ADDENDUM NO. 1

PROJECT NAME: Atlas Ranch Elementary

CLIENT NAME: Jarrell ISD

ADDENDUM DATE: November 3, 2026

Job No. 01949-04-01
Drawn By: MRC
Date: 10/08/2026
Sheet No. CU.27

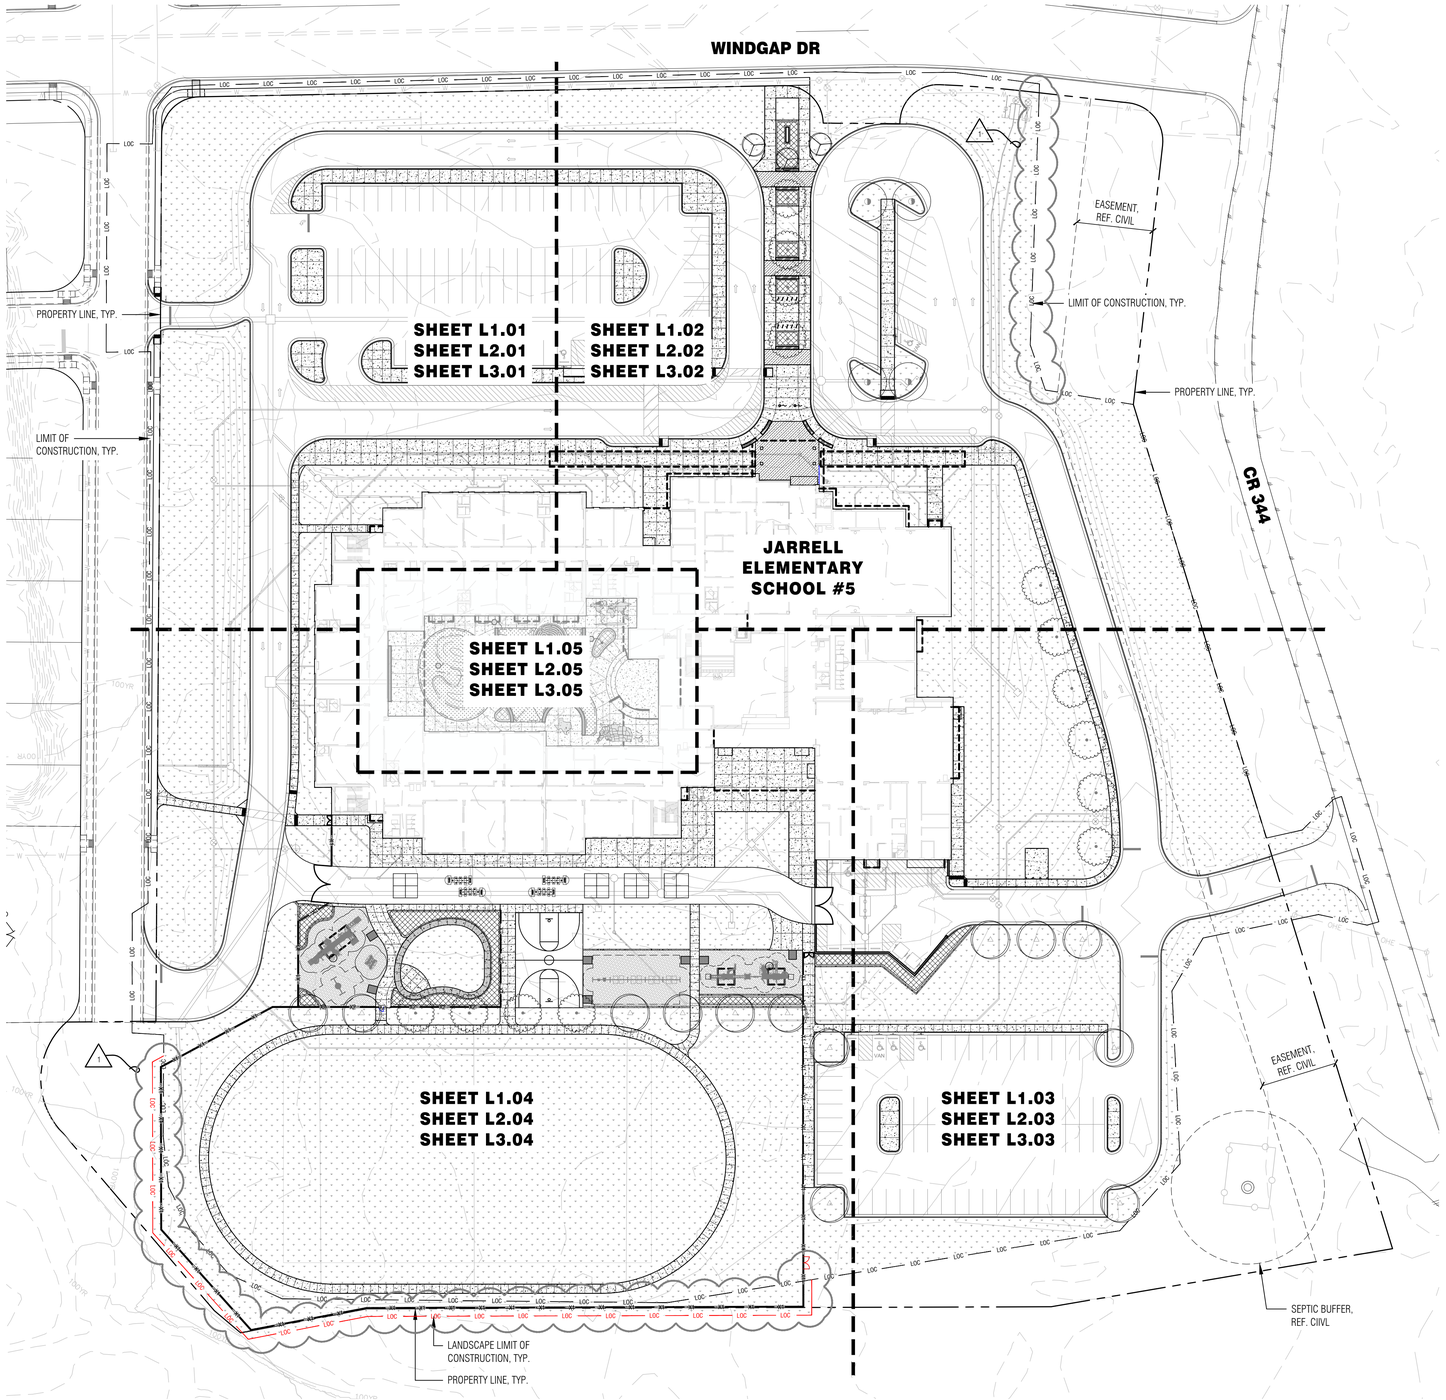
AD No 1, CIVIL Item 25: **To the Drawings, Sheet CU.27 "WATER DETAILS (SHEET 3 OF 3)"**

Job No.	Sheet No.
1949-04-01	L1.00
Drawn By: KGC	
Date: 10/08/2026

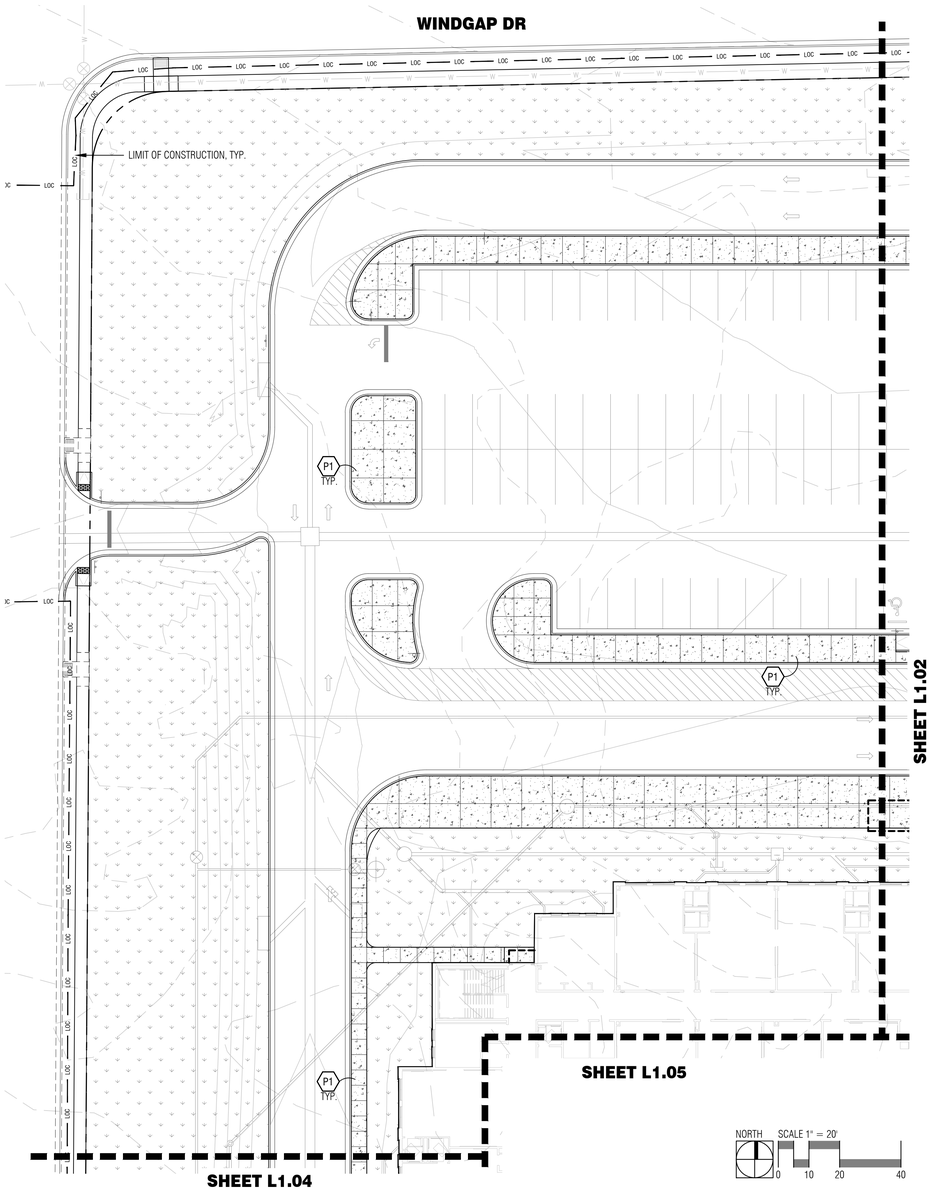
AD No 1, LANDS Item 4: **To the Drawings, Sheet L1.00**
1) Updated Limit of Construction Boundary

Job No. 1949-04-01	Sheet No. L1.01
Drawn By: KGC	
Date: 10/08/2026

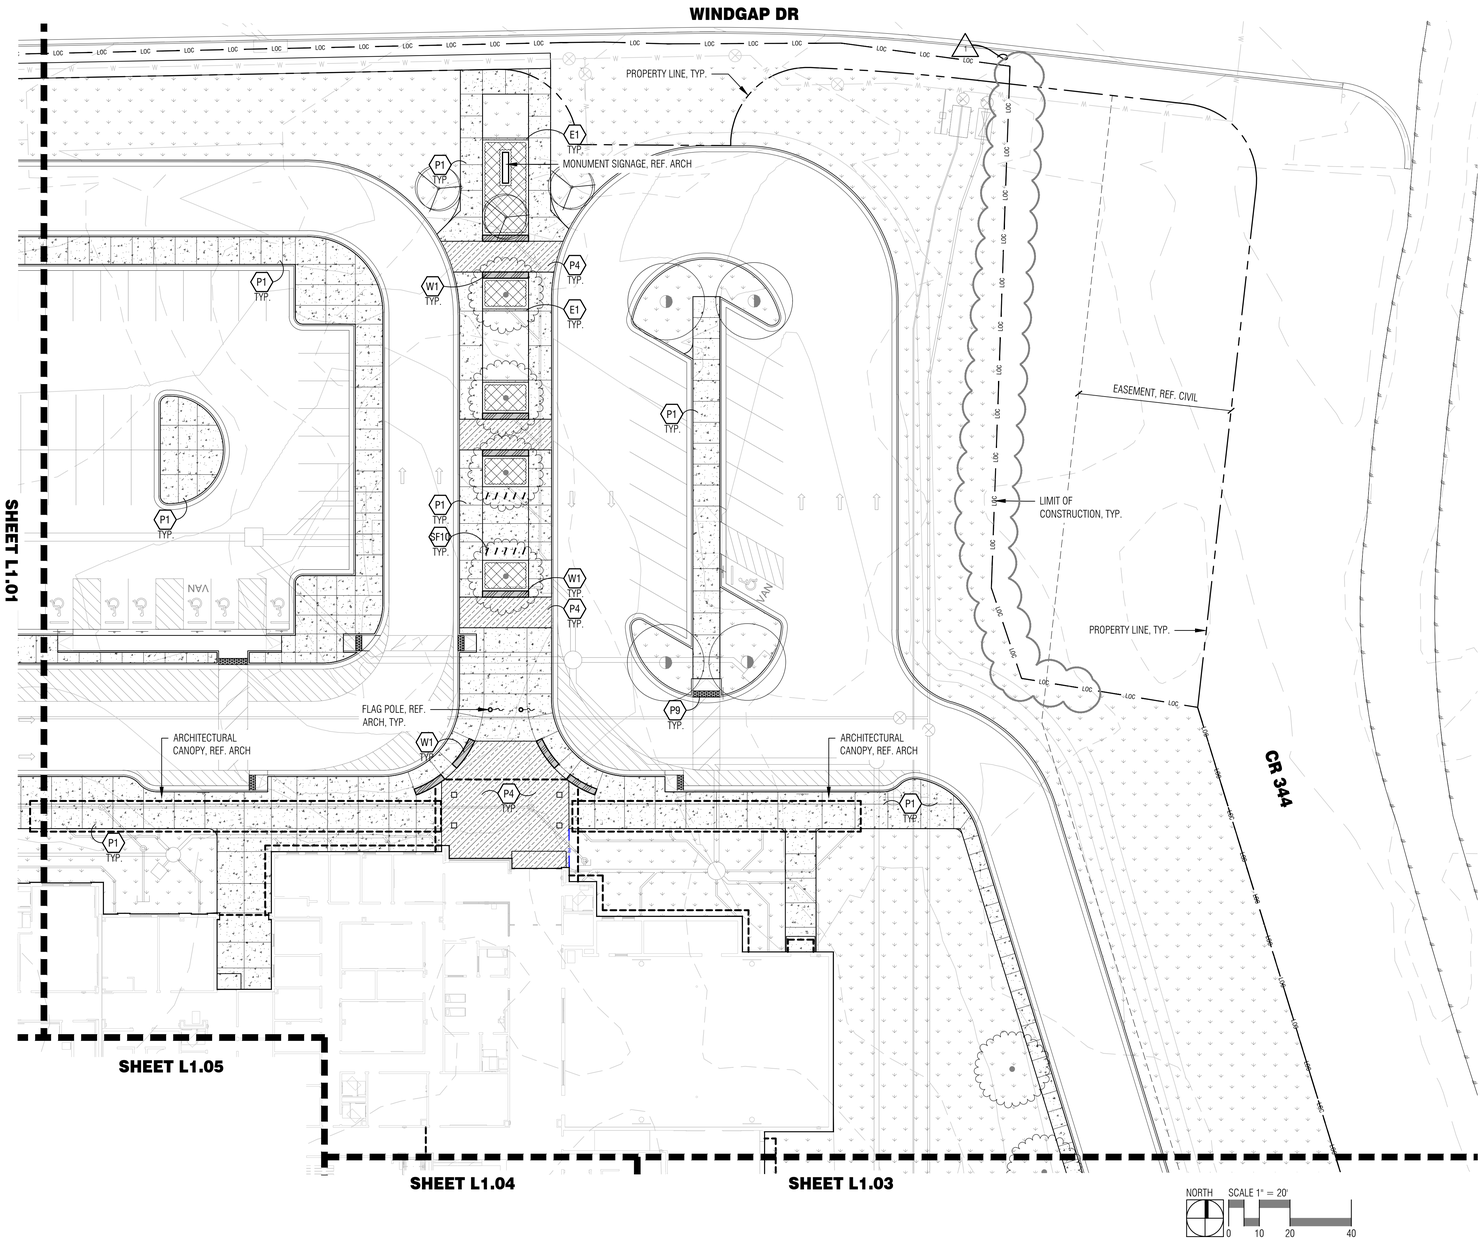
AD No 1, LANDS Item 5: **To the Drawings, Sheet L1.01**
2) P10 (Hardwood Mulch) on Construction Key has been removed
3) All Site Furnishing Key detail notes have been updated to include OFOI

Job No.	Sheet No.
1949-04-01	L1.02
Drawn By: KGC	
Date: 10/08/2026

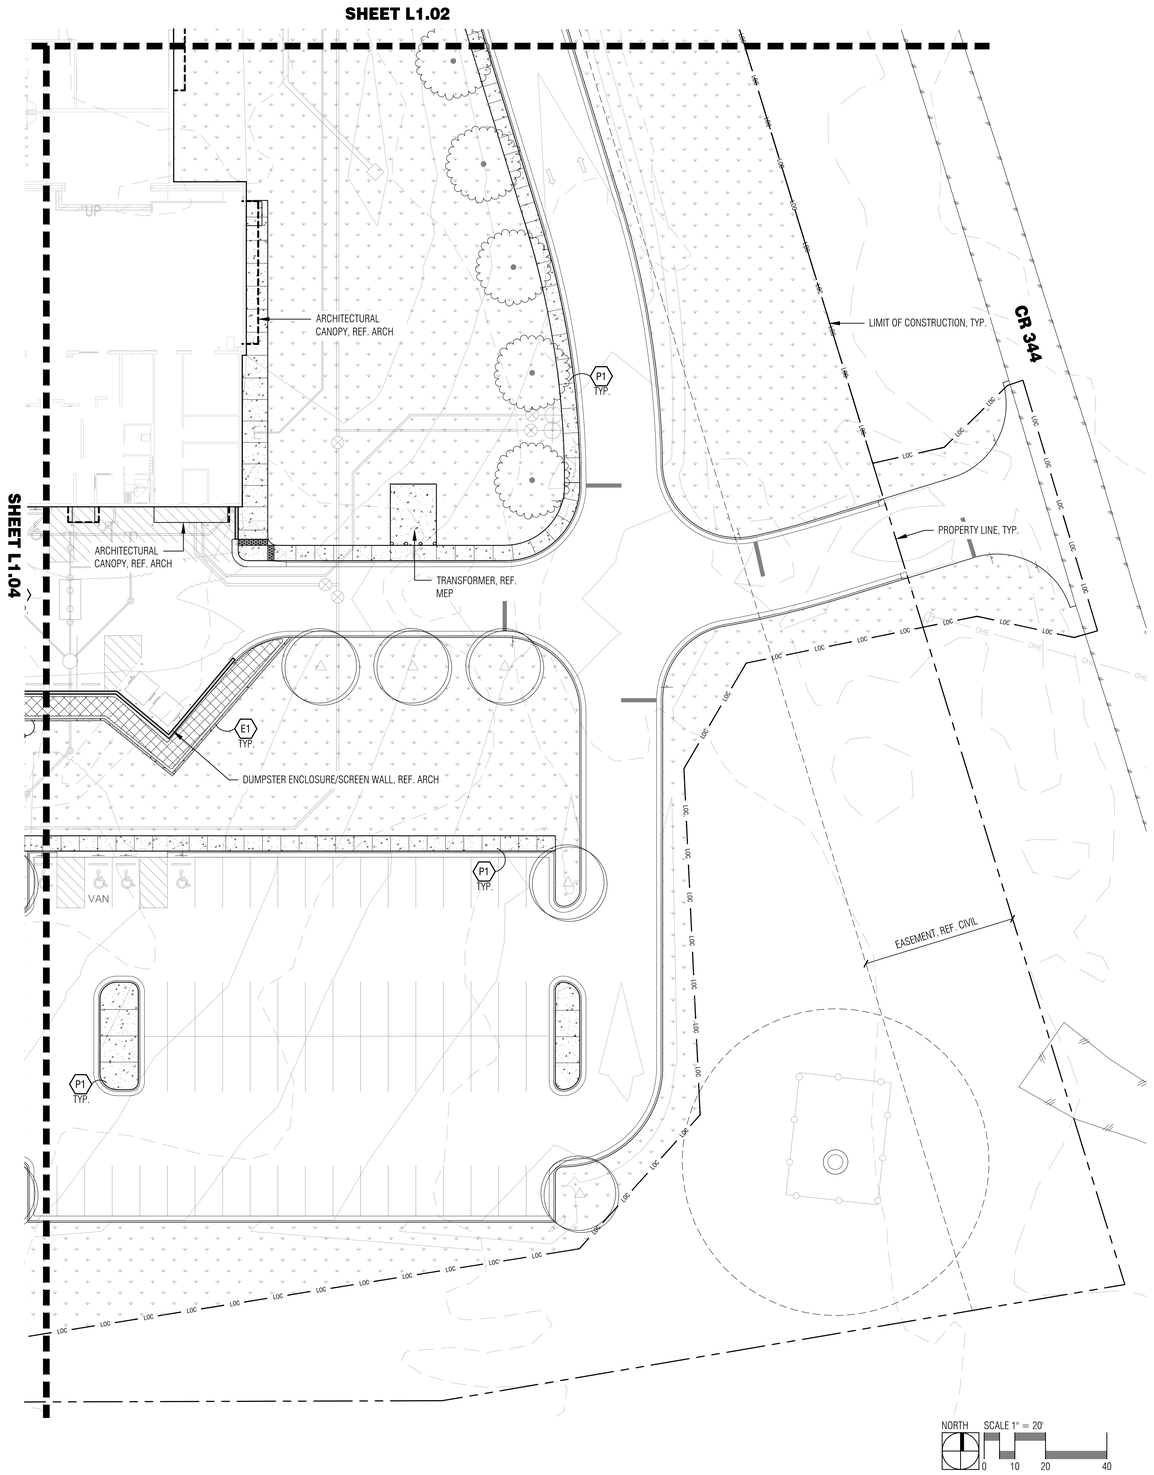
AD No 1, LANDS Item 6: **To the Drawings, Sheet L1.02**
4) P10 (Hardwood Mulch) on Construction Key has been removed
5) All Site Furnishing Key detail notes have been updated to include OFOI
6) Sod updated to extend all the way to the Limit of Construction

Job No.	Sheet No.
1949-04-01	L1.03
Drawn By: KGC	
Date: 10/08/2026

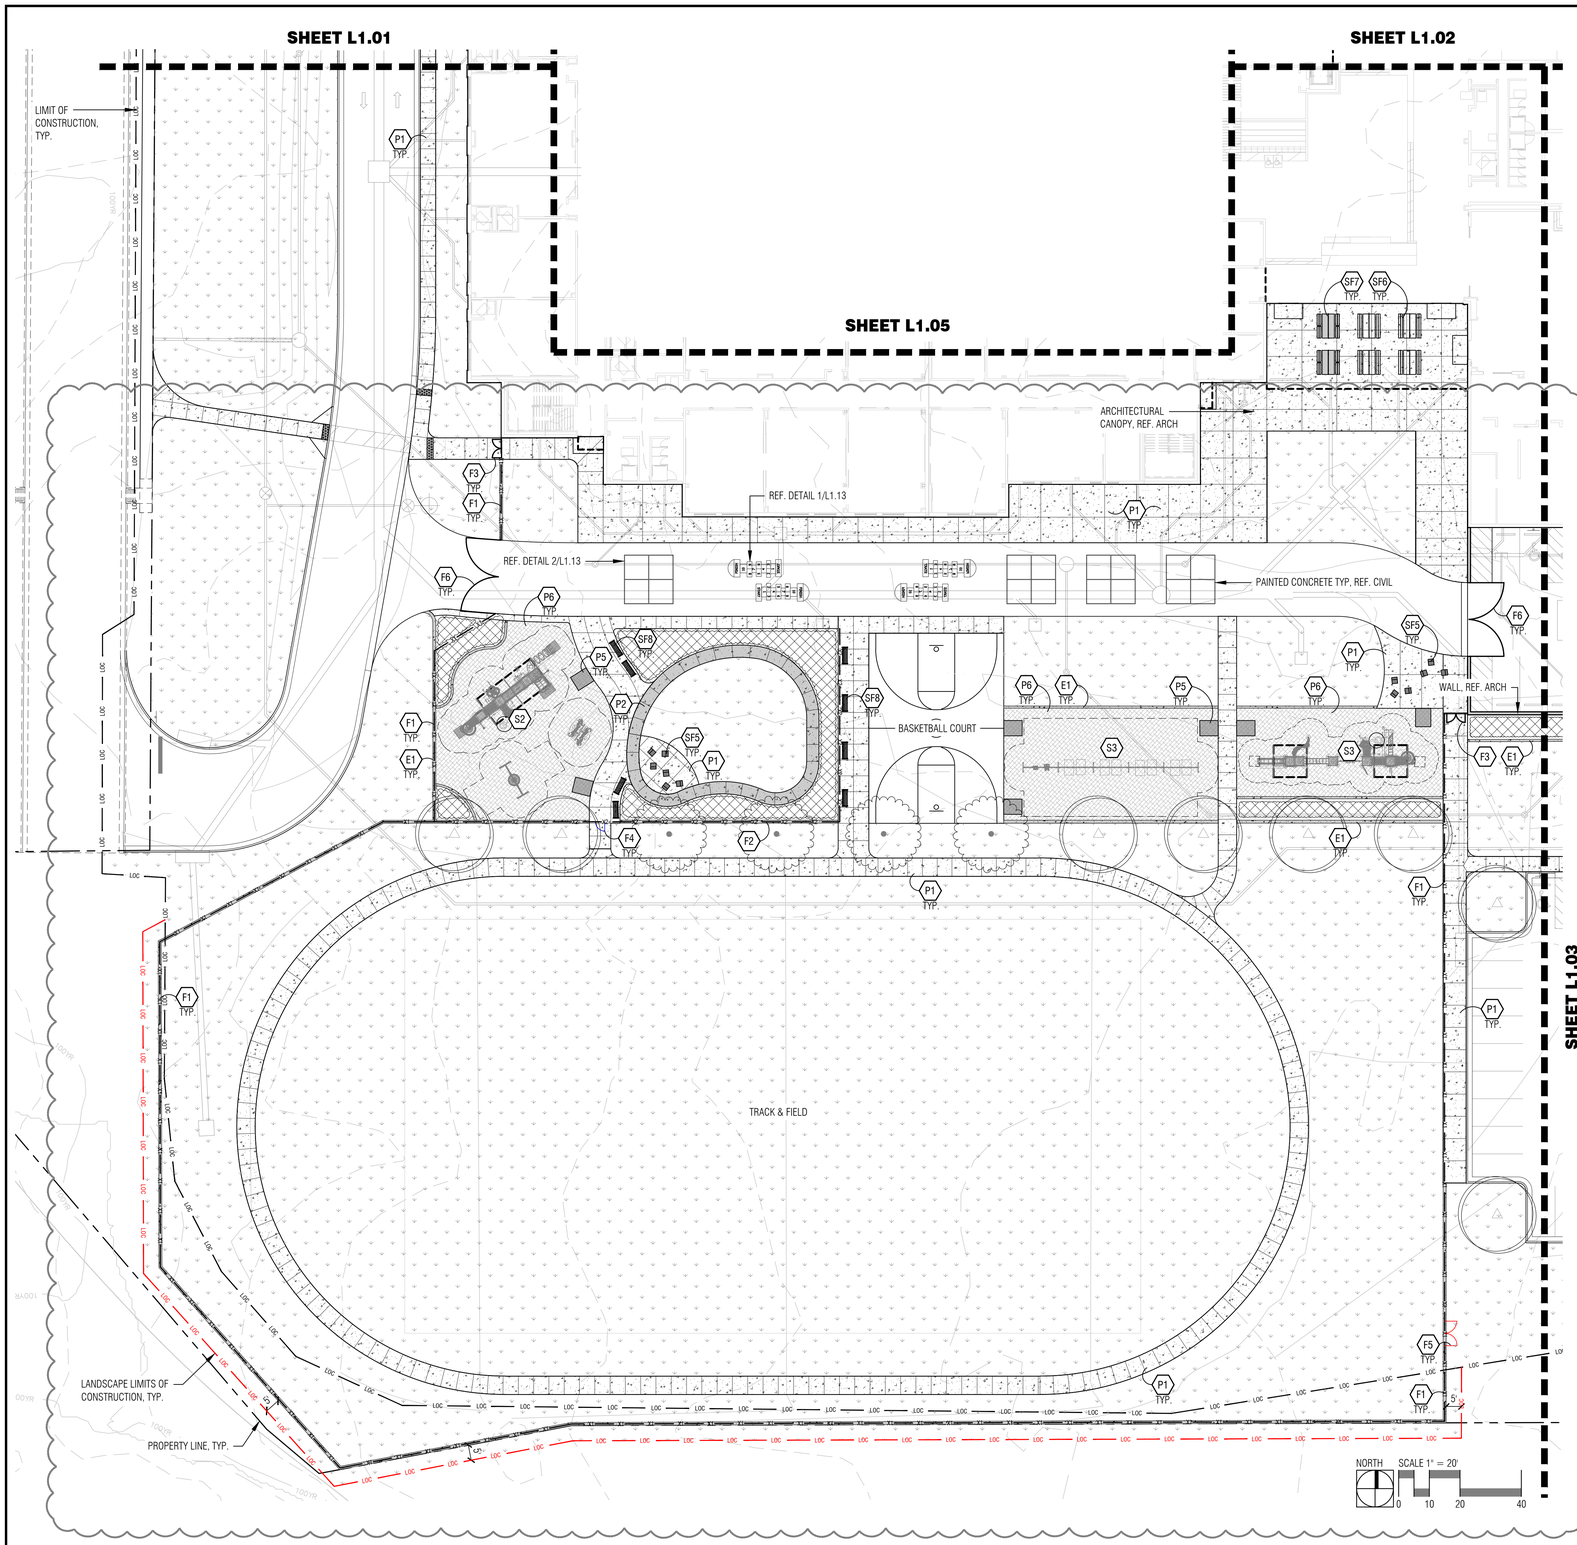
AD No 1, LANDS Item 7: **To the Drawings, Sheet L1.03**
7) P10 (Hardwood Mulch) on Construction Key has been removed
8) All Site Furnishing Key detail notes have been updated to include OFOI

Job No.	Sheet No.
1949-04-01	L1.04
Drawn By: KGC	
Date: 10/08/2026

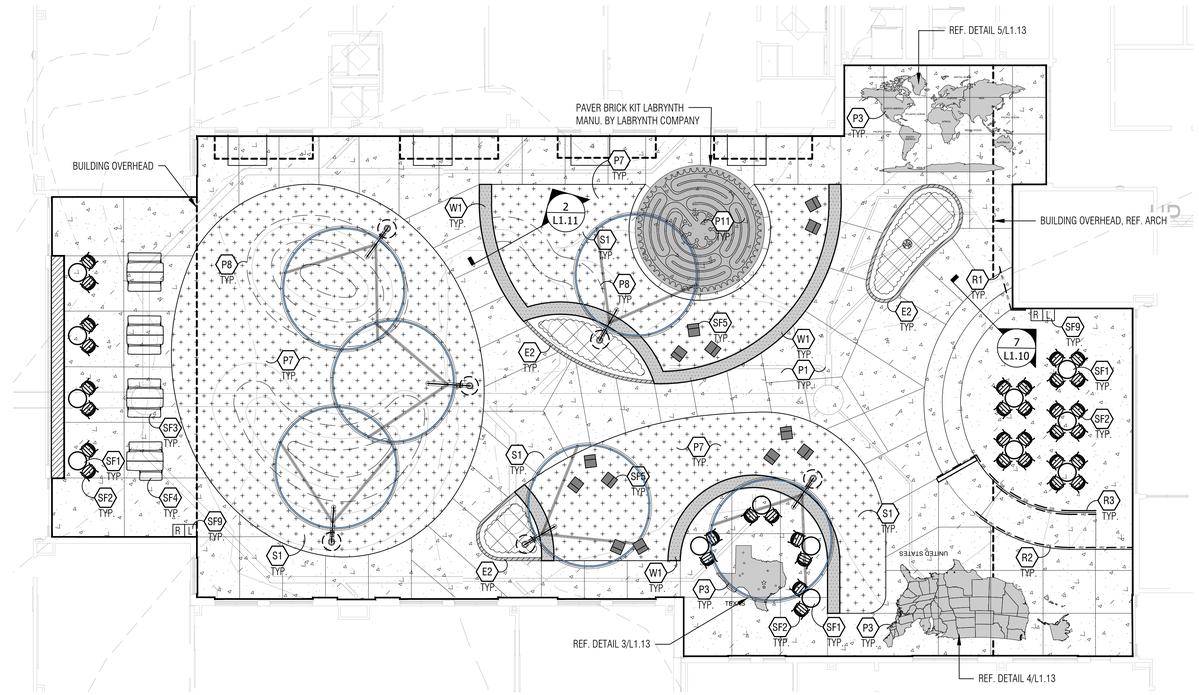
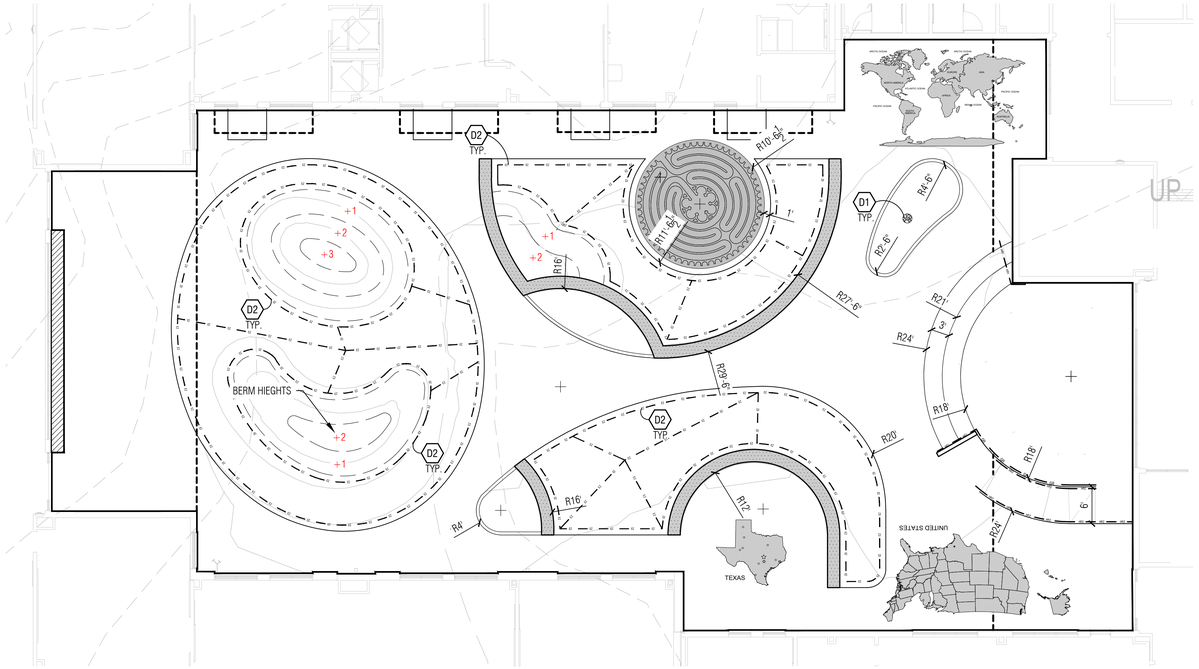
AD No 1, LANDS Item 8: **To the Drawings, Sheet L1.04**
9) P10 (Hardwood Mulch) on Construction Key has been removed
10) All Site Furnishing Key detail notes have been updated to include OFOI
11) Updated Limit of Construction Boundary
